# Video Intercom DS-KM9503 Main Station

## Release Note (2024-06-24)

| Device Model | Firmware Version   |
|--------------|--|
| DS-KM9503    | VIS_MAINSTATION_R2_EN_STD_V1.2.0_build240614<br>VIS_MAINSTATION_R2_EN_NEU_V1.2.0_build240614 |

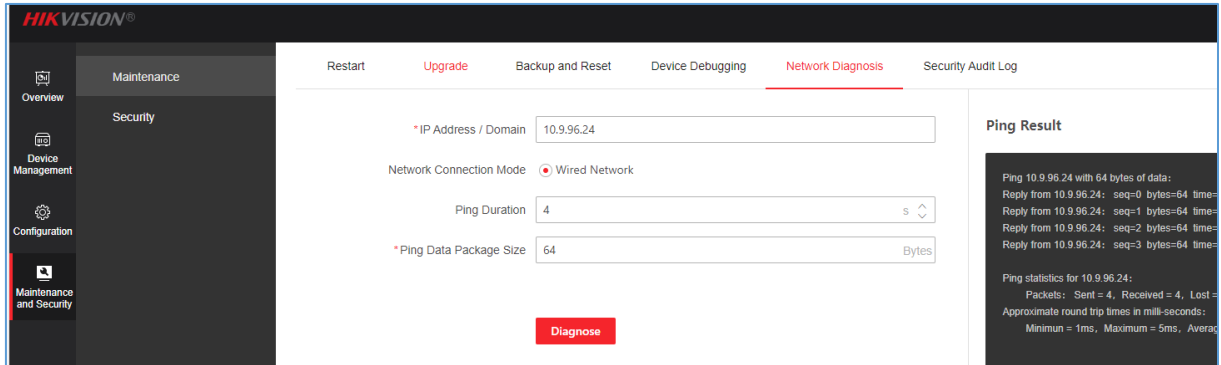
### 3. Add ping tools on web page for easier checking network issue.

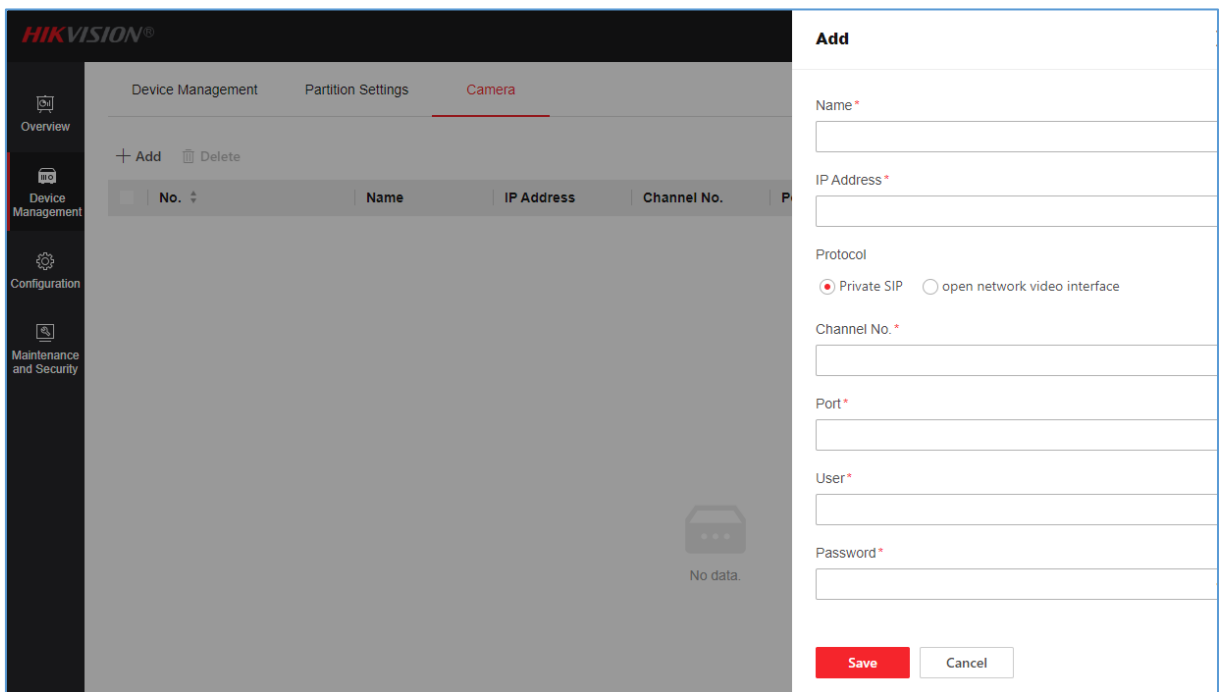
### 4. Support adding ip camera in local UI and web, support forwarding the ip camera video stream to indoor station

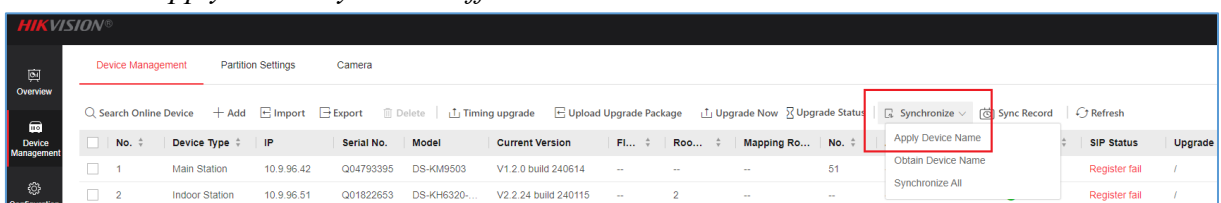
### 5. Support set and get the device name to / from indoor and door station

- a. if you set the name of indoor station and door station from local UI, it will be send to indoor station and door station automatically.
- b. If you set the name of indoor station and door station from web page, you have to apply manually to take effect.

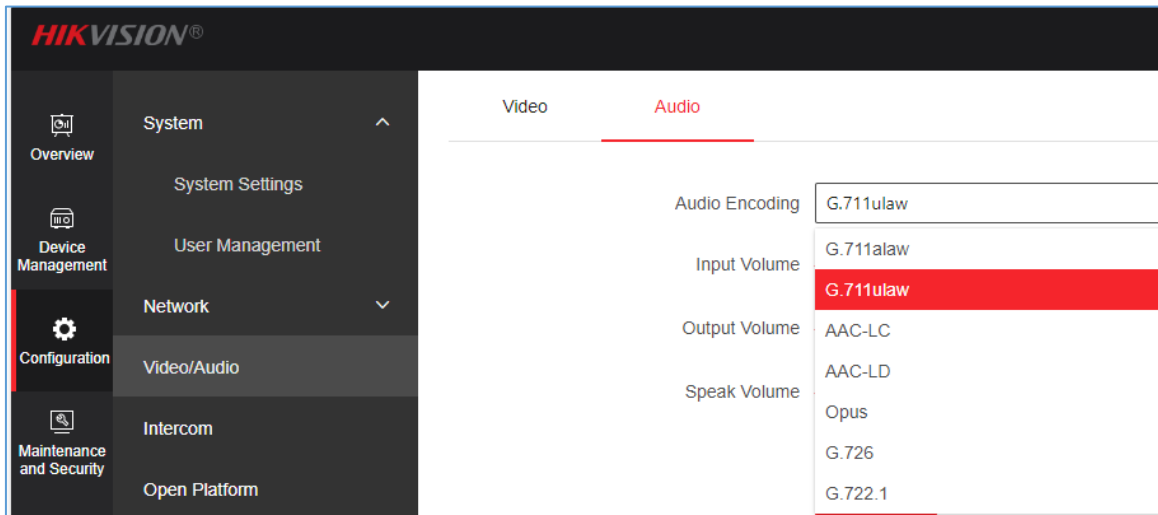
8. Support more audio formats and audio format automatic negotiation (in manually call forwarding)

**Note:** audio coding format negotiation currently is only supported between Hikvision intercom devices, in VOIP (standard SIP) only support G.711u and G.711a audio format.
